Index of code change proposals

Yellow highlighted area represents changes suggested by Chuck since meeting in Boston

The Deck Code Coalition (DCC) is a diversified group of interested people representing building officials, manufacturing suppliers, National Association of Homebuilders, American Wood Council, engineering companies and academia who have worked since the 2012 IRC in an effort to capture the safest deck practices from across the country. Deck safety is a huge issue and we have been meeting for over three years in an effort to codify how to build a deck:

FIGURE R507.1.1
FREESTANDING DECKS

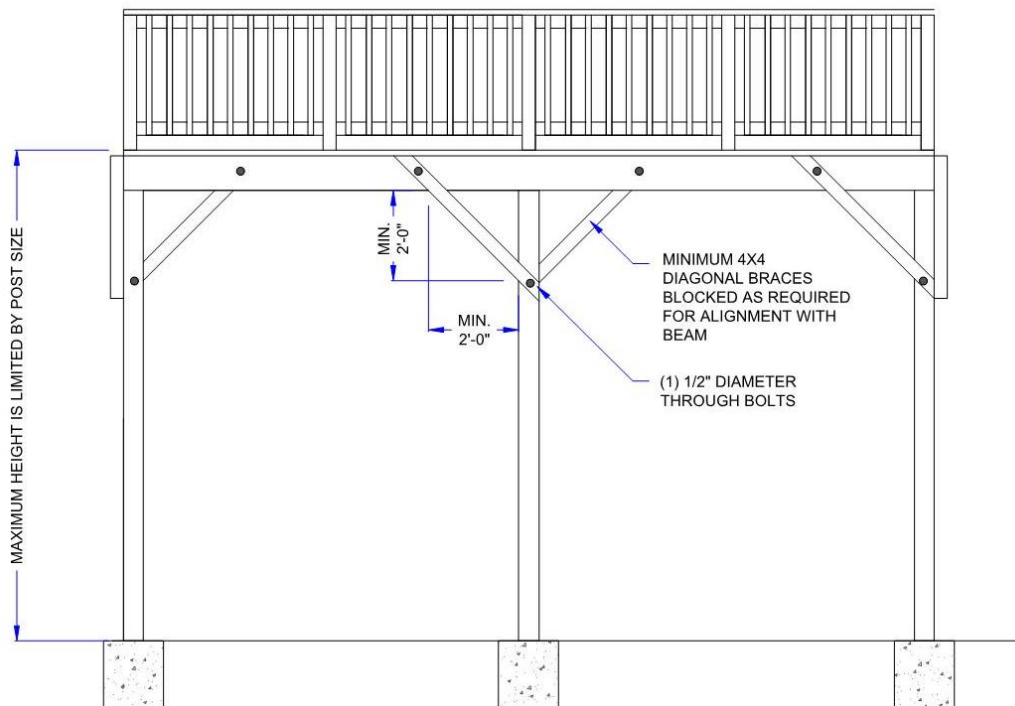
R507.1.1 Freestanding decks. Freestanding decks shall be supported by at least two parallel rows of beams and shall be limited in height by the post specified in Table R507.4. The lateral load resistance shall be permitted to be provided by diagonal braces in both directions in accordance with Figure R507.1.1, or by other methods in accordance with accepted engineering practice

This code change offers new charging language in R507.1 to acknowledge freestanding decks. Previously there are several references to freestanding decks, but there has never been any design consideration provided. This code change tries to differentiate between freestanding and ledgered decks that are supported by another structure.

FIGURE R507.56

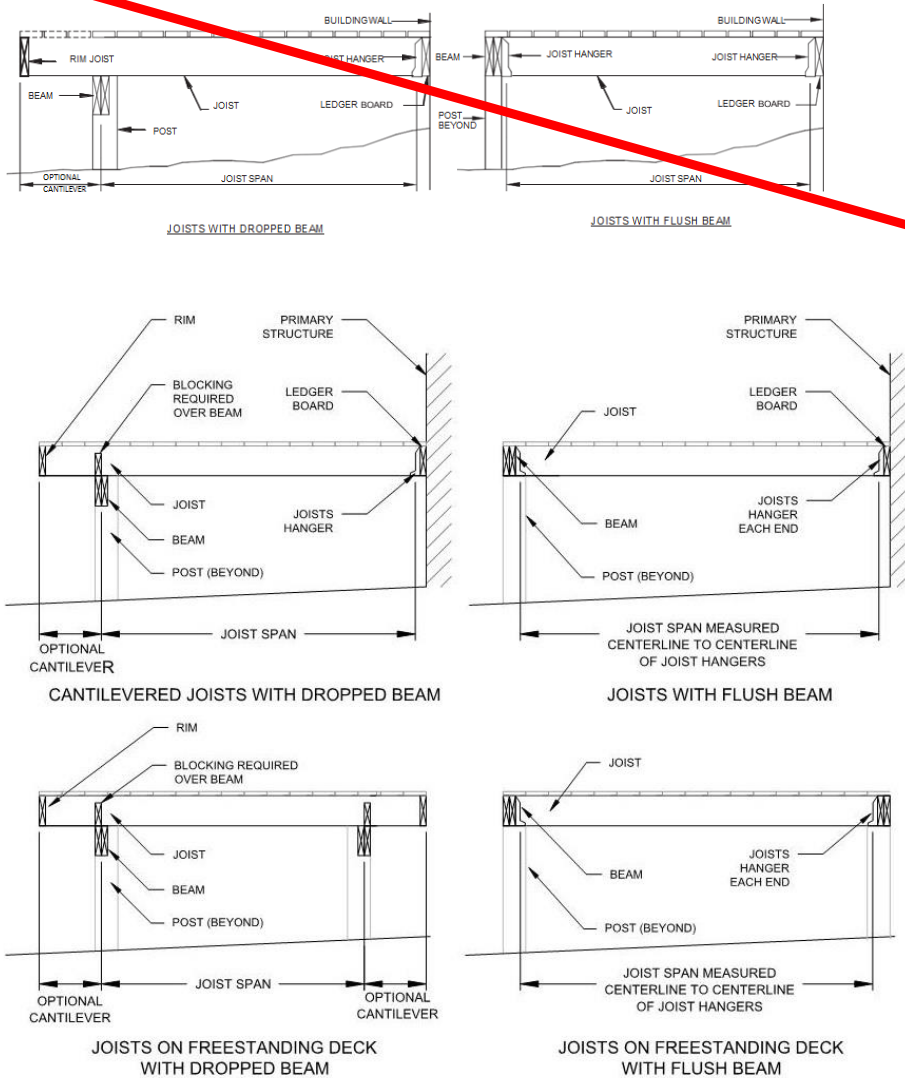
4. Renumber and replace figure with new figure.

FIGURE R507.4.1

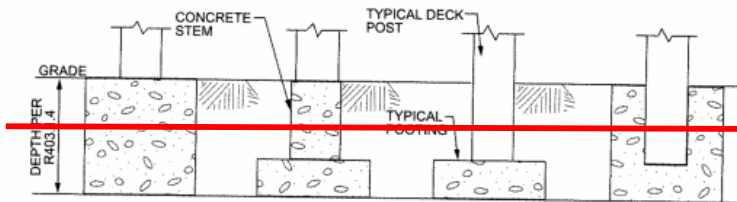
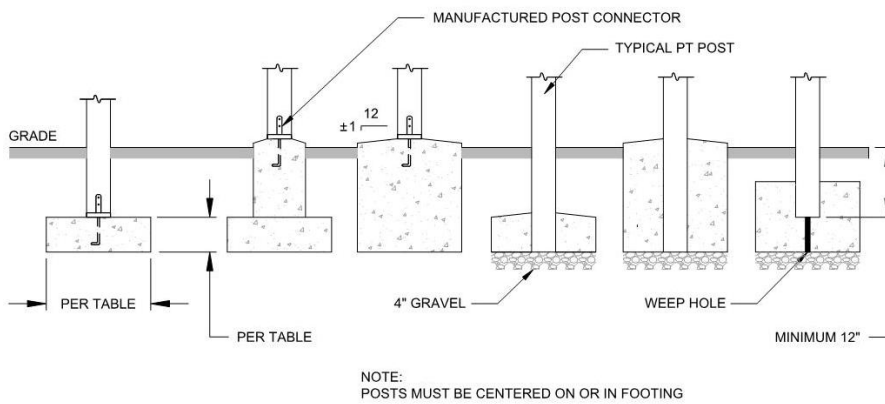
R507.8.4.1 Deck post to deck footing connection. Where posts shall bear on concrete footings in accordance with Section R403 and Figure R507.8.4.1, posts shall be restrained to prevent lateral displacement at the bottom support. Such lateral restraint shall be provided by manufactured connectors installed in accordance with Section R507 and the manufacturers' instructions or a minimum post embedment of 12 inches in surrounding soils or concrete piers or other approved footing system.

3. Replace Figure R507.4.1

FIGURE R507.65
TYPICAL DECK BEAM SPANS

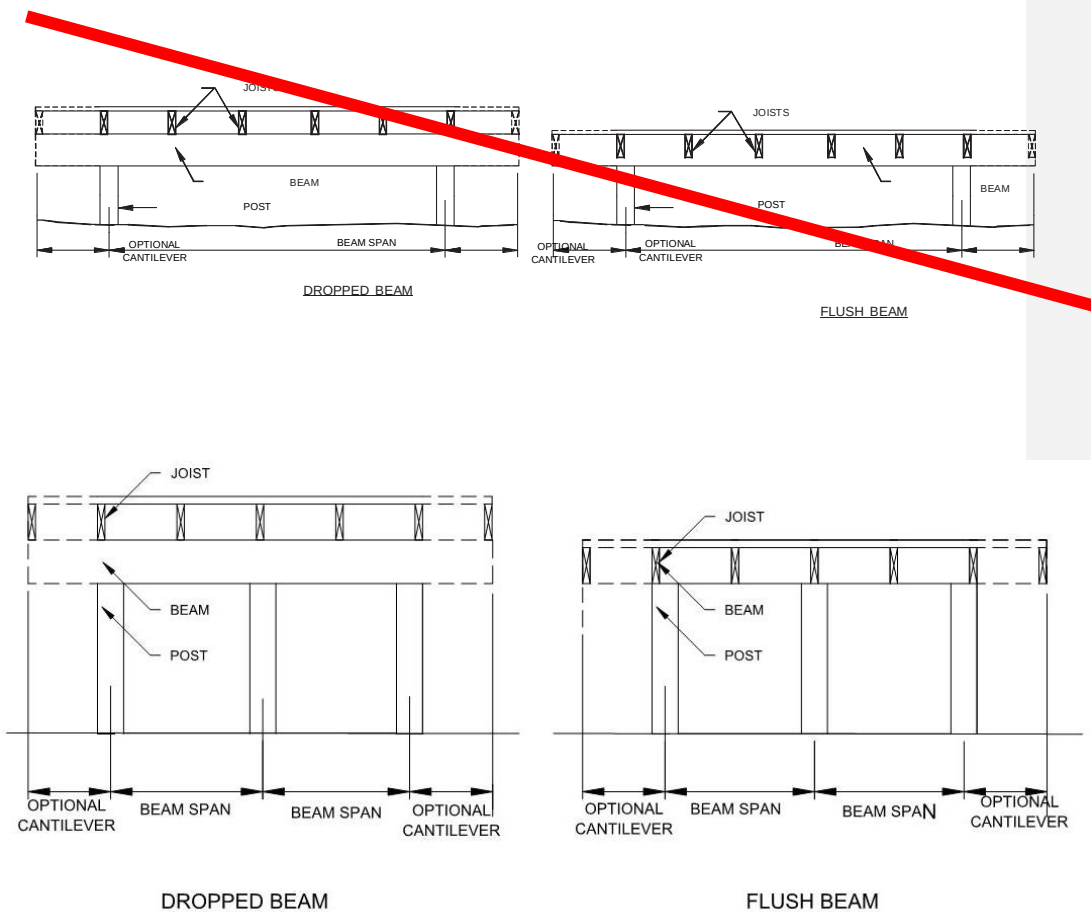
R507.6~~5~~ **Deck Beams.** Maximum allowable spans for wood deck beams, as shown in Figure R507.~~65~~5, shall be in accordance with Table R507.~~65~~5. Beam plies shall be fastened with two rows of 10d (3-inch x 0.128-inch) nails minimum at 16 inches (406 mm) on center along each edge. Beams shall be permitted to cantilever at each end up to one-fourth of the actual beam span. Splices of multispan beams shall be located at interior post locations~~R507.7.~~

2. Add or replace Table B507.5, Figure R507.5, R507.1(1) and R507.1(2)

FIGURE R507.5.1(1)

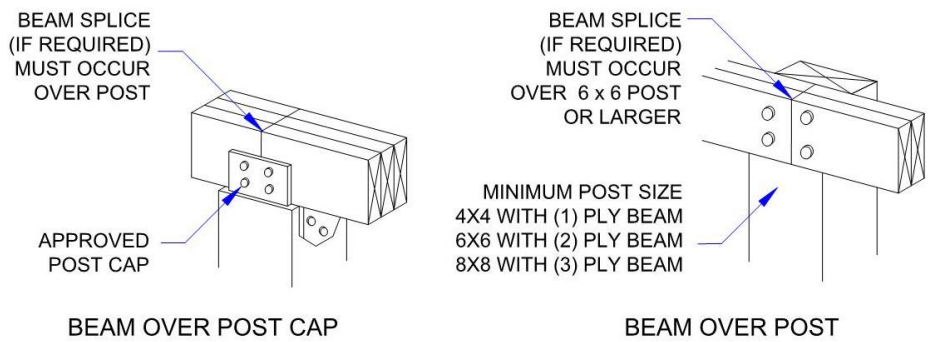
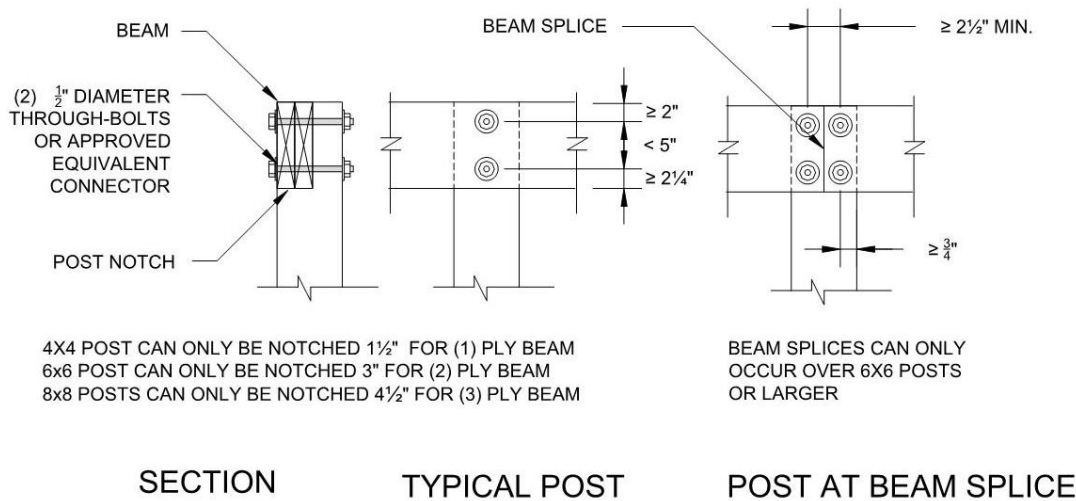
R507.7.15.2 Deck post to deck beam connection. Deck beams shall be attached to wood deck posts in ~~accordance with Figure R507.7.1 or by other equivalent means a manner~~ capable to resist of resisting lateral displacement vertical and horizontal applied loads. Connections shall be accordance with Figures R507.5.1 (1) and R507.5.1 (2). Manufactured post-to-beam connectors shall be sized for the post and beam sizes. All bolts shall have washers under the head and nut.

This change is submitted to more clearly show how beams are to be connected to posts.

FIGURE R507.56

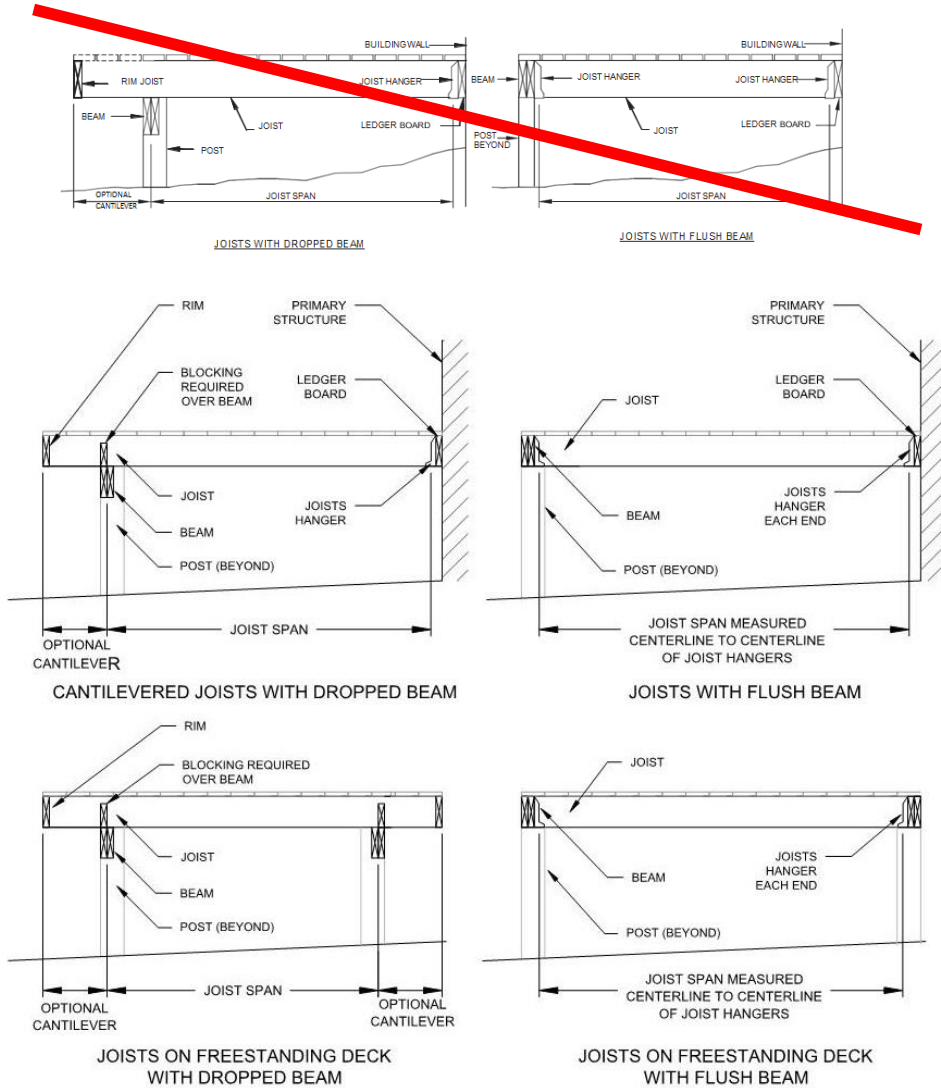
R507.5-6 Deck joists. Maximum allowable spans for wood deck joists, as shown in Figure R507.~~56~~, shall be in accordance with Table R507.~~56~~. ~~Deck joists shall be permitted to cantilever not greater than one-fourth of the actual, adjacent joist span. The~~ maximum joist spacing shall be limited by the decking material in accordance with Figure R507.7. The maximum joist cantilever shall be limited to the actual joist span divided by 4 or the maximum cantilever length specified in Table R507.5, whichever is less.

This change was submitted because the committee wanted to change the way the cantilever length was displayed in the 2015 table. The committee thought that the information might be misleading, and wanted to provide the prescriptive cantilever length based on the deflection limits.

FIGURE R507.2.19 (2)
PLACEMENT OF LAG SCREWS AND BOLTS IN BAND JOISTS

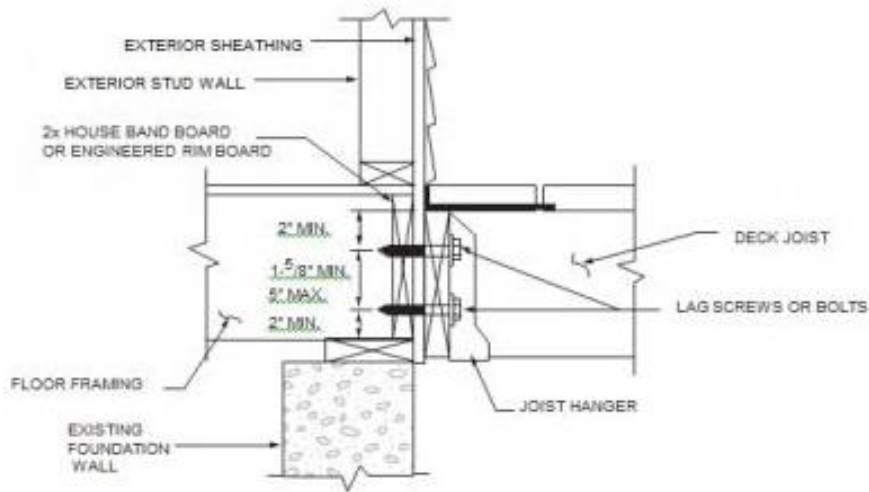
- a. Lag screws or bolts shall be staggered from the top to the bottom along the horizontal run of the deck ledger in accordance with Figure R507.2-1-9. (1).
- b. Maximum 5 inches.
- c. For engineered rim joists, the manufacturer's recommendations shall govern.
- d. The minimum distance from bottom row of lag screws or bolts to the top edge of the ledger shall be in accordance with Figure R507.2-1-9. (1).

1. This change is to specify the minimum grade of band joists. As originally written, it implied that:
 - wood band joist had to be spruce-pine-fir
 - LVLs had to be Douglas fir.
2. Other changes to the text were written to clean up the intention.

FIGURE R507.2.39.4 (1)
DECK ATTACHMENT FOR LATERAL LOADS
For SI: 1 inch = 25.4 mm.

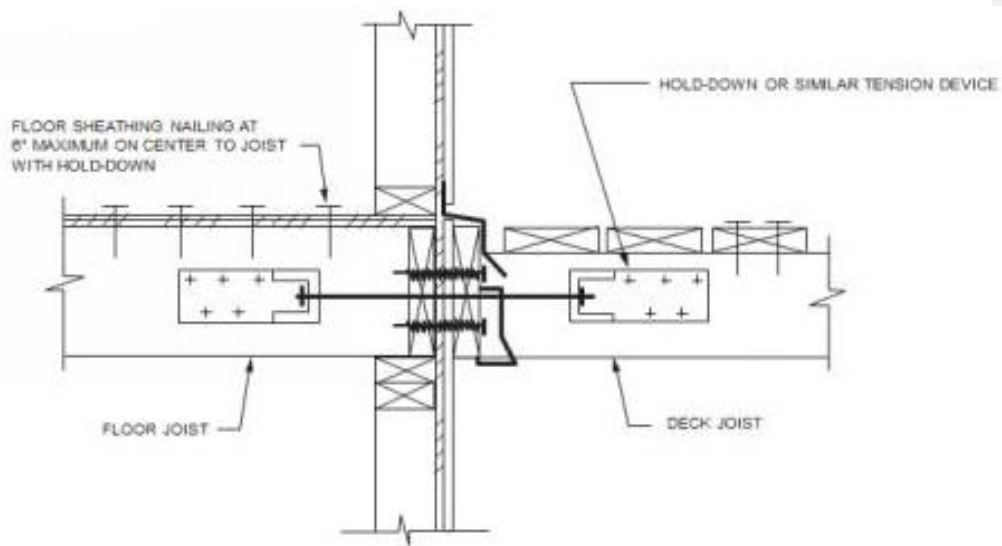
R507.29.4 Deck lateral load resistance. Resistance to lateral loads required by Section R507.1 shall be permitted to be in accordance with Figure R507.2-39.4(1) or R507.2-39.4(2). Where the lateral load connection is in accordance with Figure R507.2-39.4(1), hold-down tension devices shall be installed in not less than two locations per deck, within 24-inches of each end of the deck. Each device shall have an allowable stress design capacity of not less than 1,500 pounds. Where the lateral load connections are provided in accordance with Figure R507.2-39.4(2), the hold-down tension devices shall be installed in not less than four locations per deck, and each device shall have an allowable stress design capacity of not less than 750 pounds.
